**CITY OF MERCED PROJECT NO. CP220061
CHANGE ORDER NO. 3**

PROJECT NAME: Community Park 42

REASON FOR CHANGE ORDER:

Additional work to add 2 additional soccer fields, 2 basketball courts. Quantity adjustment for additional asphalt per the contract unit price. Add Musco Lights, and additional work.

THE NO. 0035-02-2061
 SHEET
C1.3
 12 OF 75

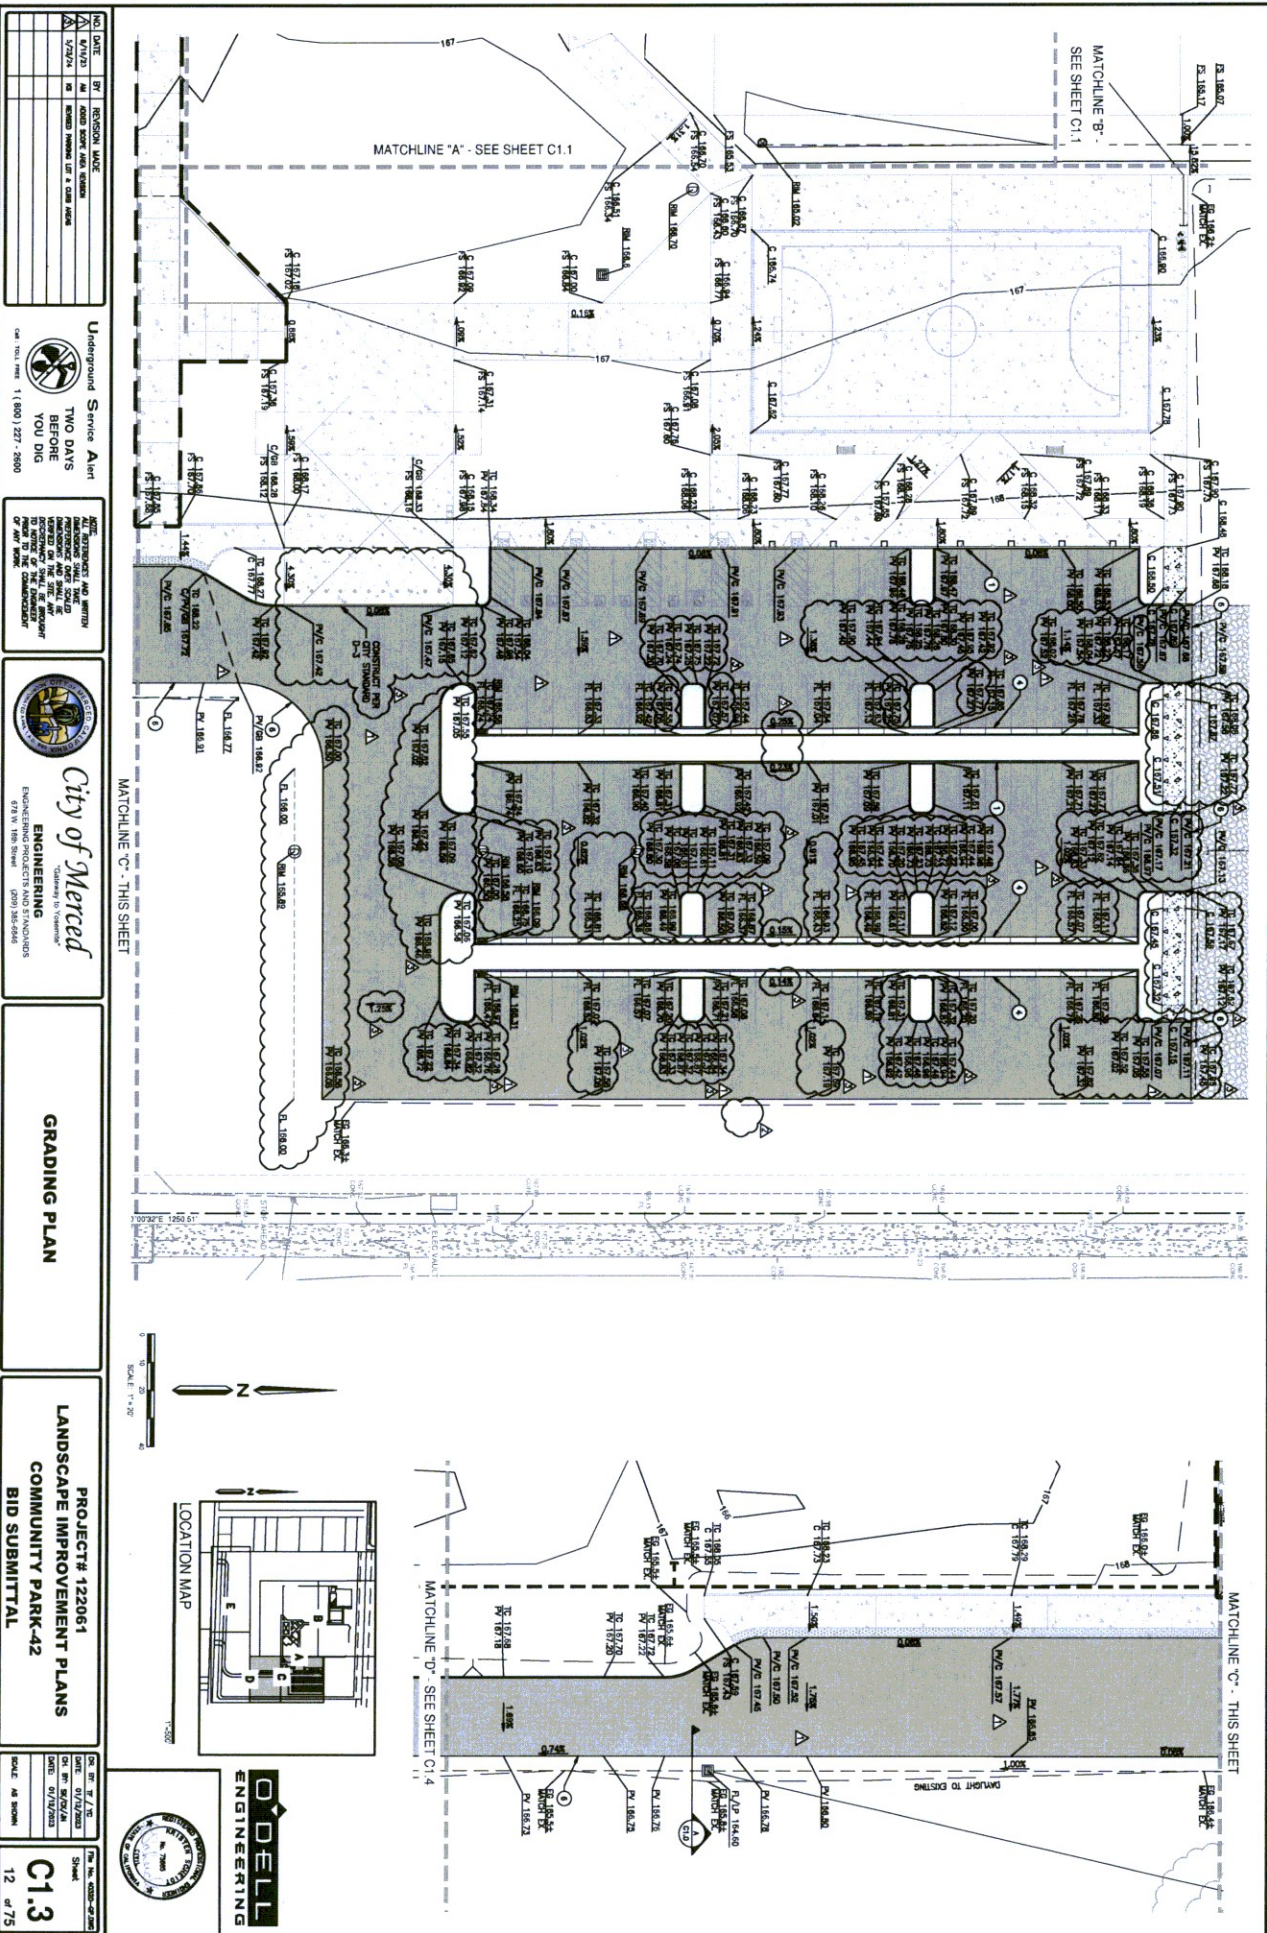
Attn: Joe Cardoso, PLS
 Project: Community Park 42
 Subject: PCO #5 – Revisions to Parking Lot & Curb Grades, & futsal court grades

Please find the below pricing. APC will provide all labor, equipment, materials, bonds, and incidentals to furnish and install the revisions to the parking lot, & grade changes at the curbs and futsal court.

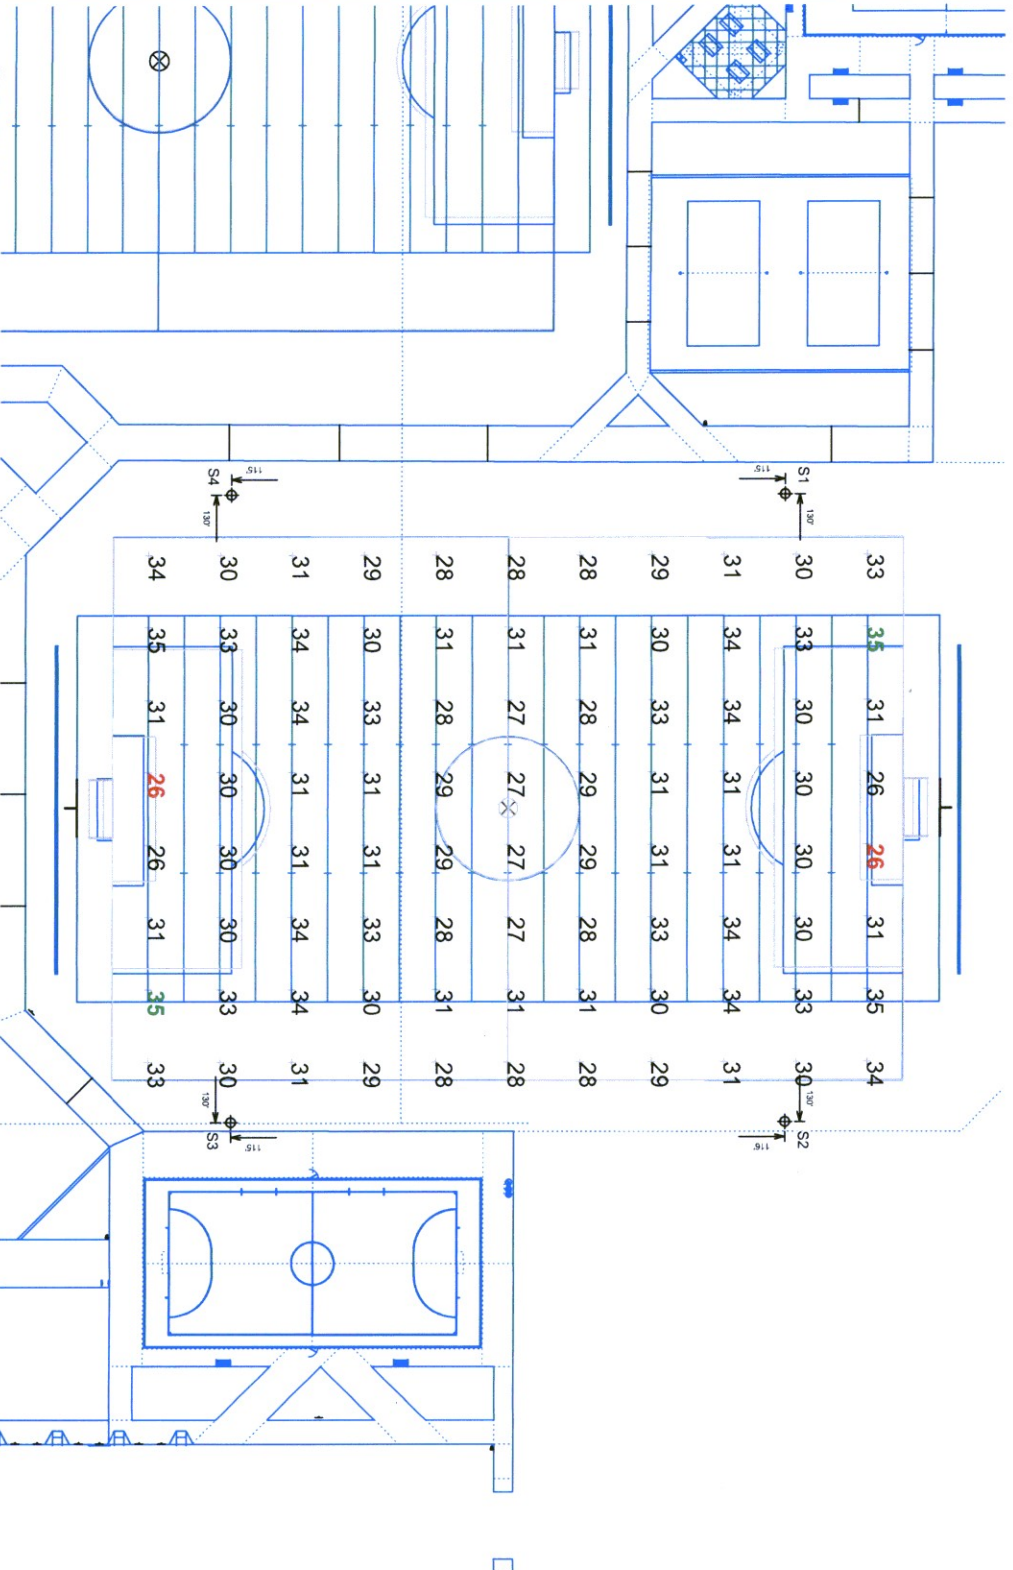
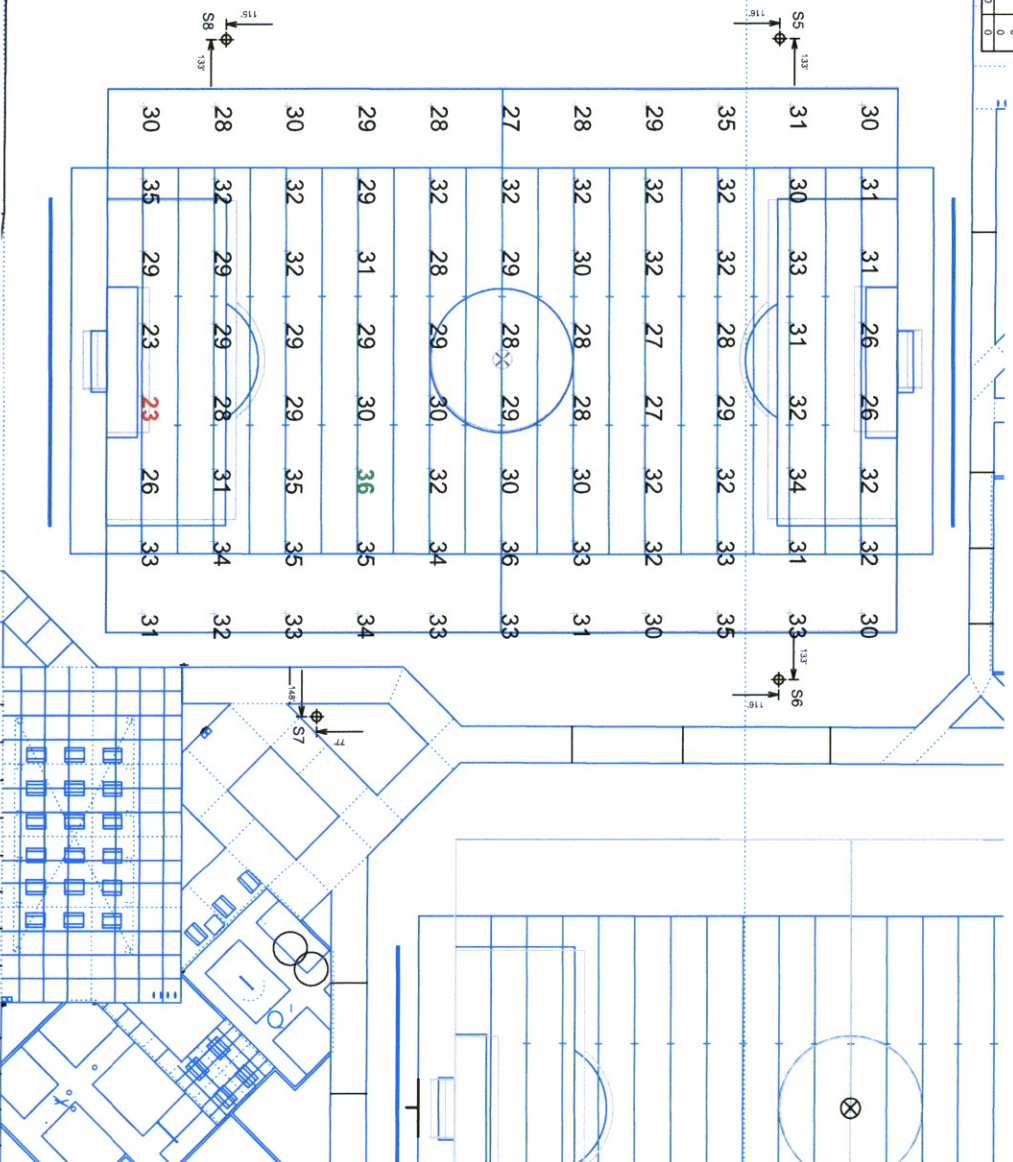
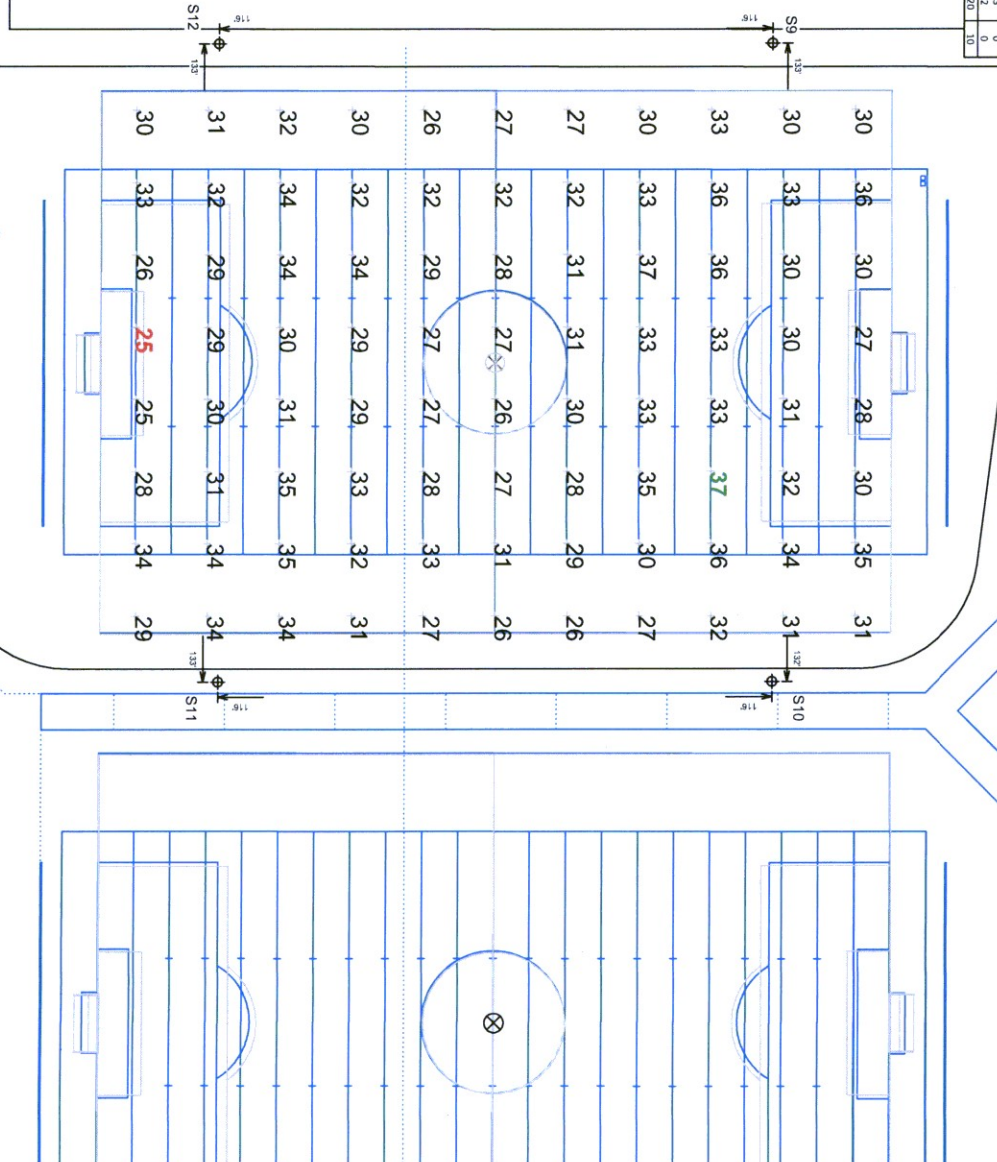
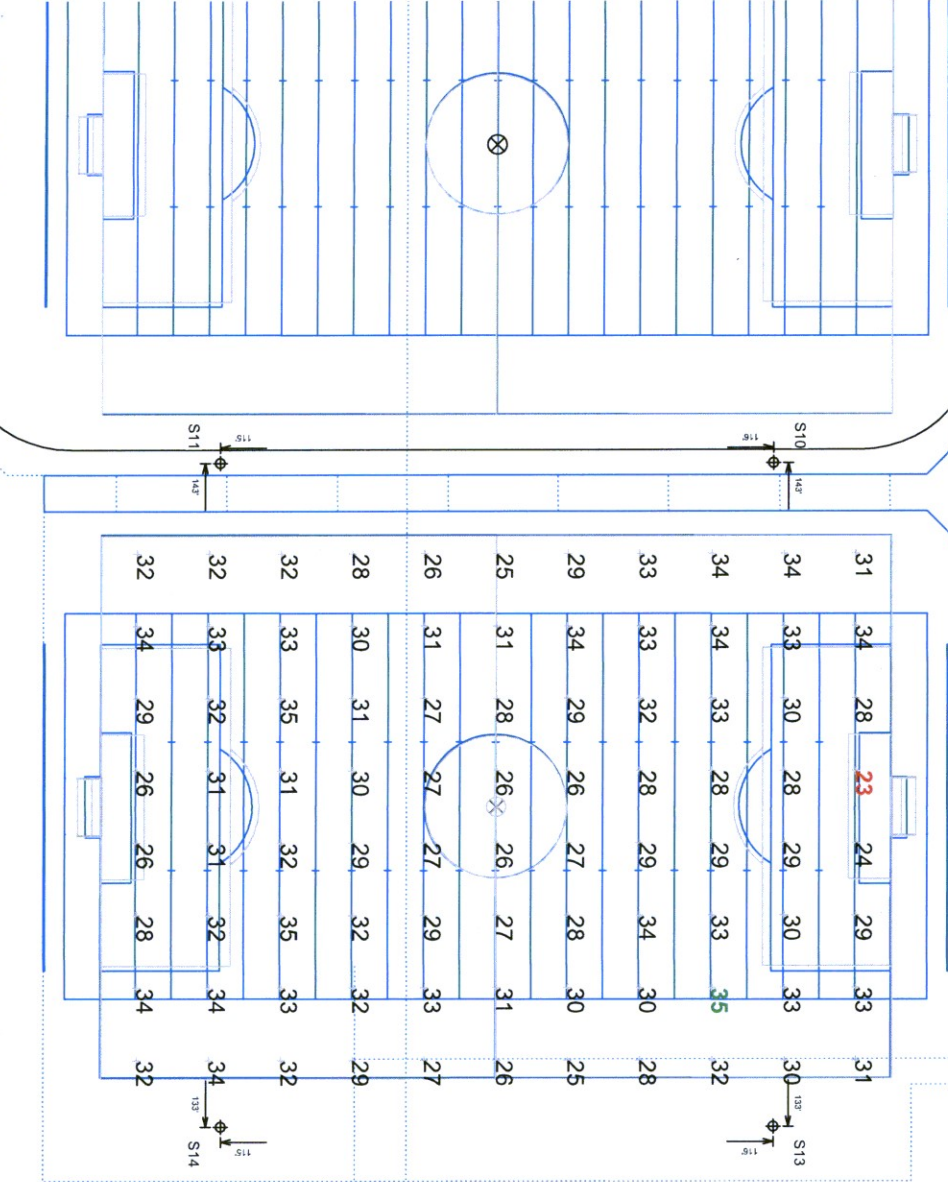
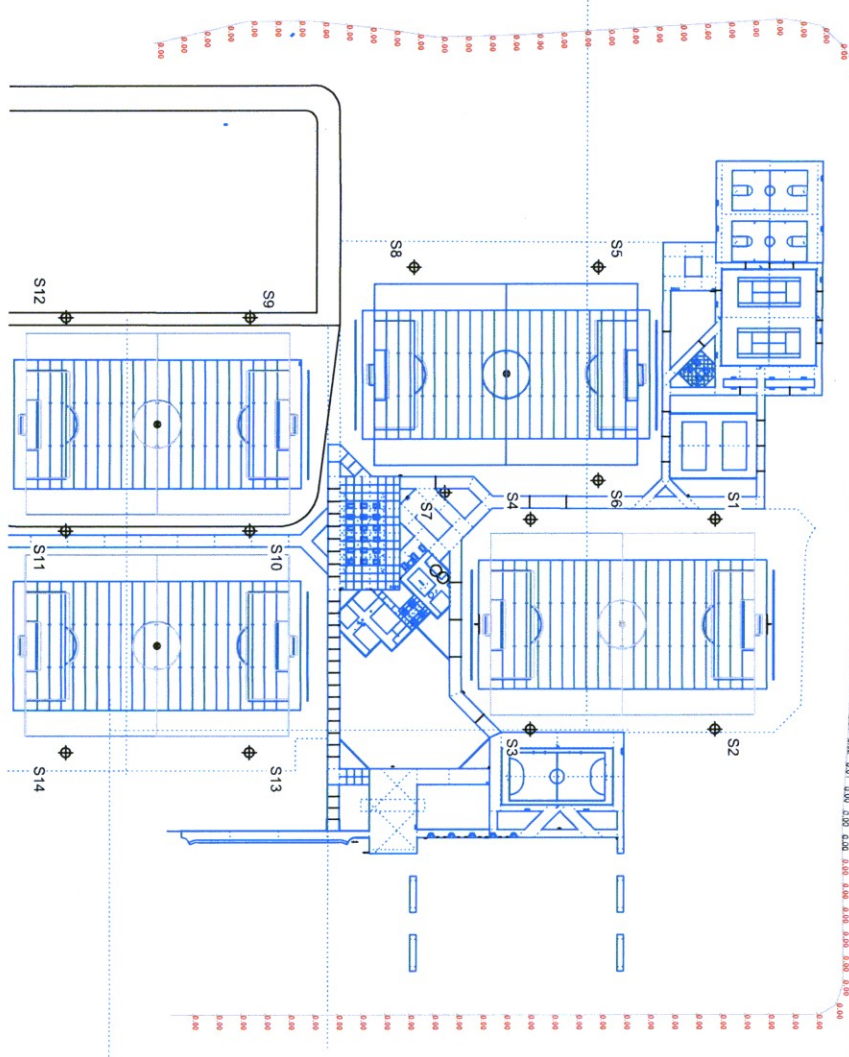
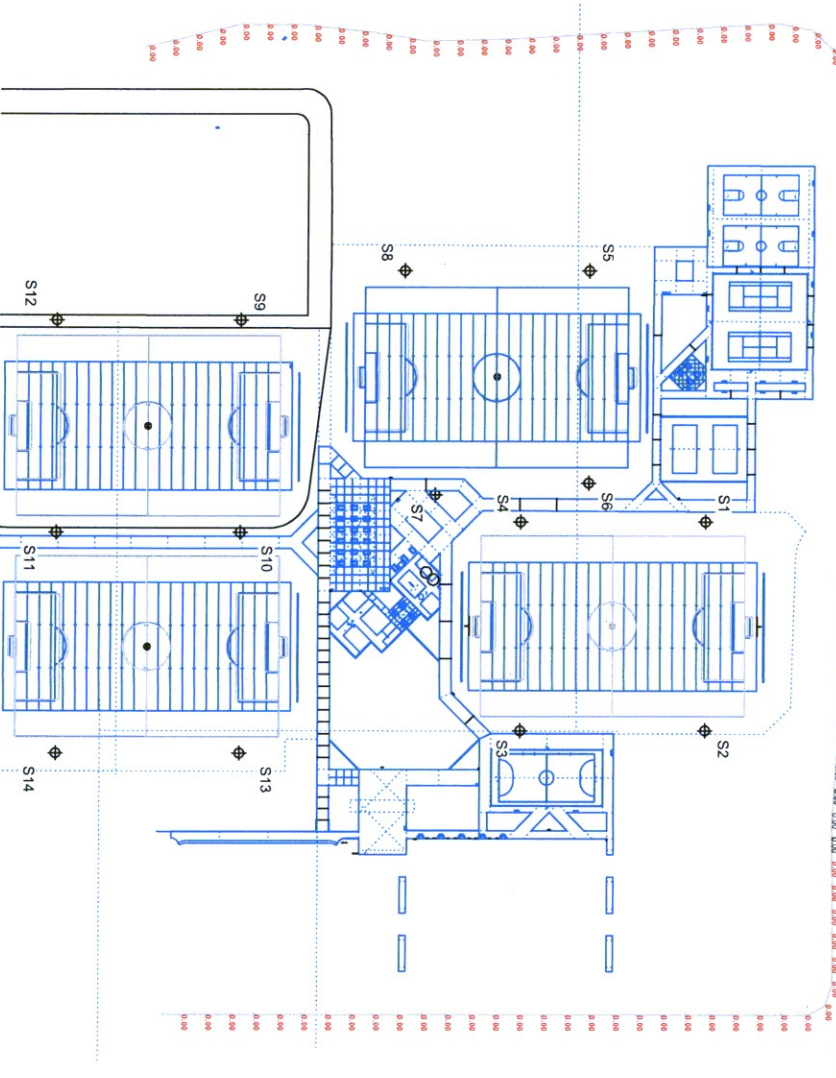
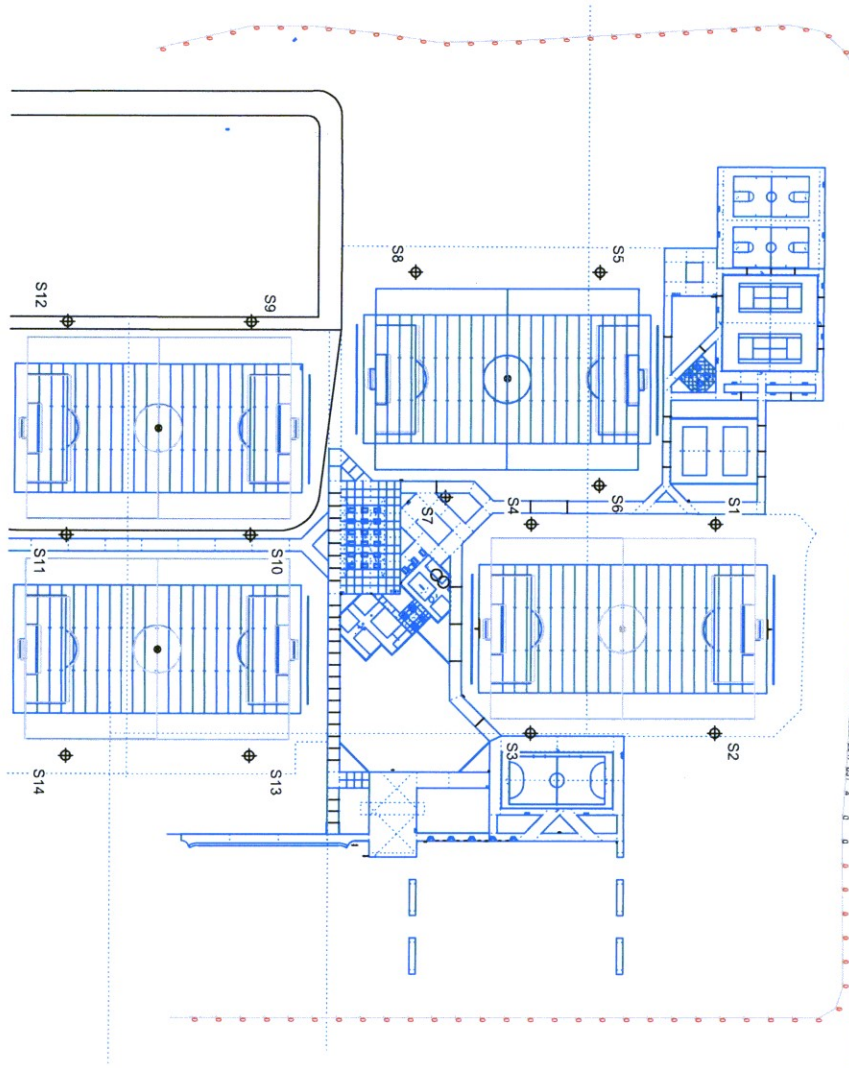
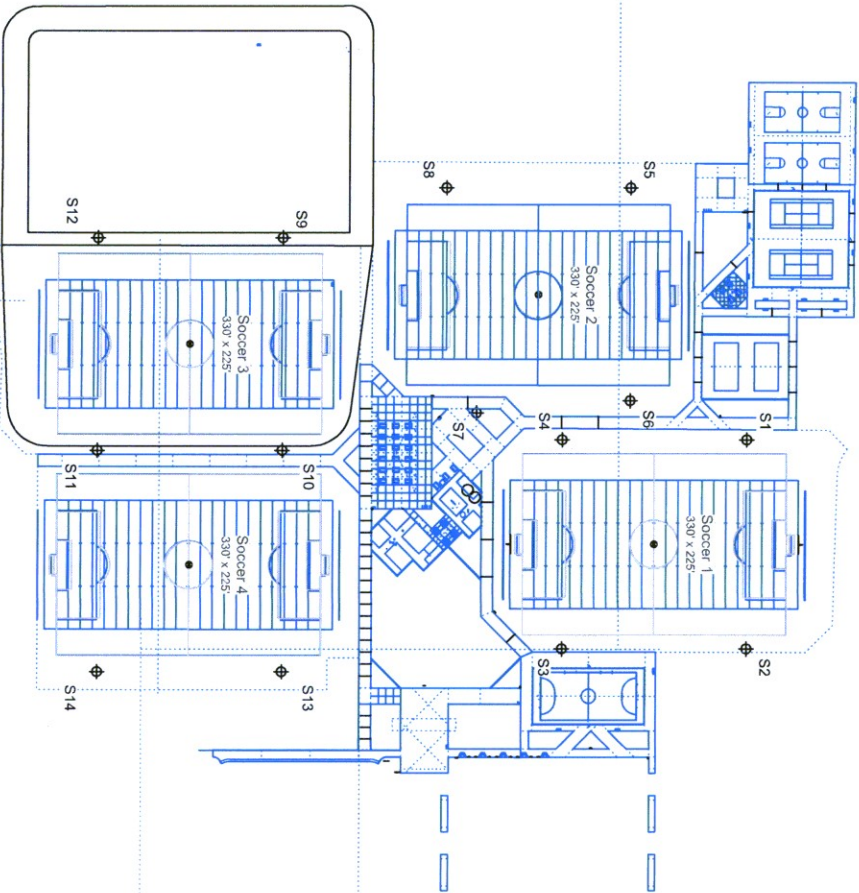
Attn: Joe Cardoso, PLS
Project: Community Park 42
Subject: PCO #4 – Musco field lighting package – R1

Please find the below pricing. APC will provide all labor, equipment, materials, bonds, and incidentals to furnish and install the Musco field lighting package. Including switchboard, panels, transformers, grounding, conduits, pull boxes, conductors, light fixtures (including poles), foundations, devices and equipment as indicated on the attached drawing.
